Field Safety Notice

21st May 2018 – FSN 1

Product: Peek Acuity Pro App

Product	Product Code	Software Version
Peek Acuity Pro App	PV_PAC_001	3.5.2

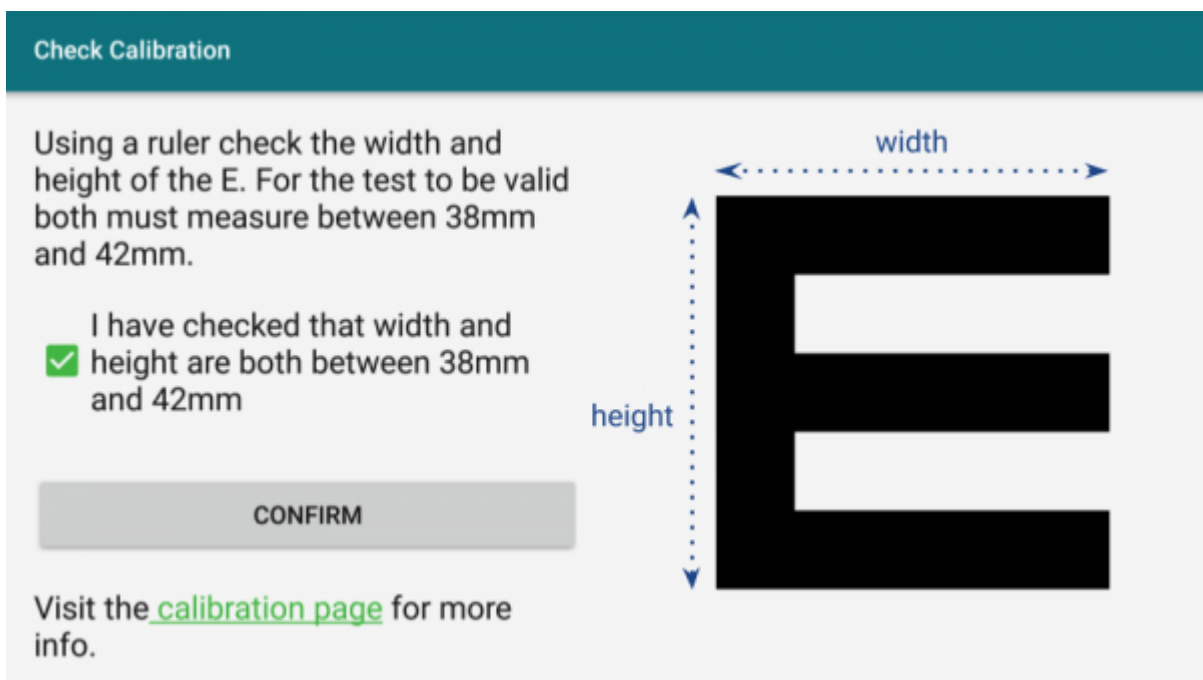
The calibration check should pop up automatically once you've updated the app. If it doesn't appear automatically, or if you want to perform calibration more than once, go to the Settings menu in the app, and select Check Calibration:

As described above, Peek Vision has released an update to Peek Acuity Pro (3.5.13) that enforces the users to perform a calibration step to identify if their device is functioning correctly by using a ruler or measuring tape to confirm the size of "E" generated by the test.

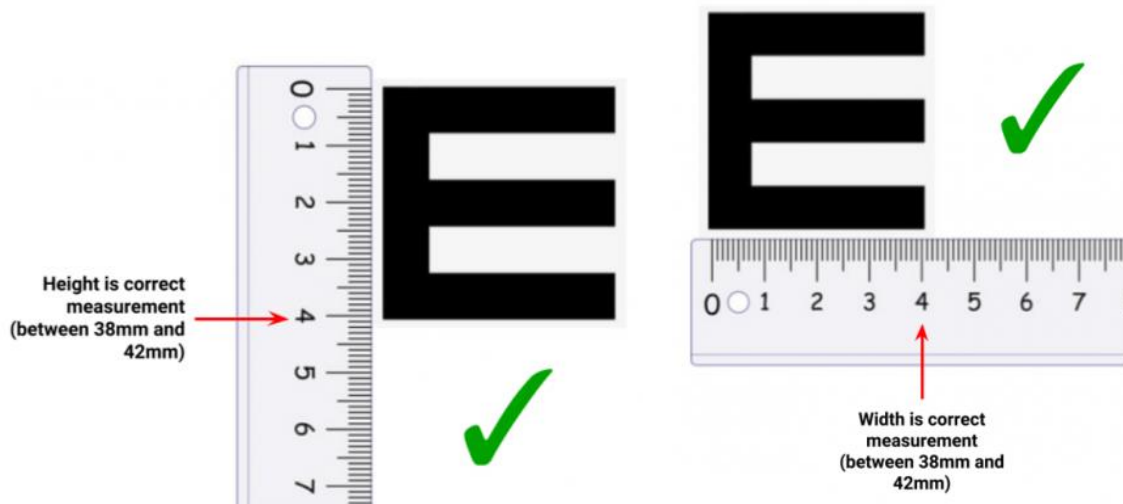
When the calibration window opens, you'll be prompted to measure the width and height of the "E" symbol:

Using a ruler or measuring tape, measure the dimensions of the E symbol as shown here:

If either or both measurements are not between 38mm and 42mm, please do not use your device to conduct Peek Acuity vision checks, as the results will be inaccurate. If you use any other apps which rely on accurate measurement (e.g. a "ruler" app), you may find that accuracy is similarly affected.
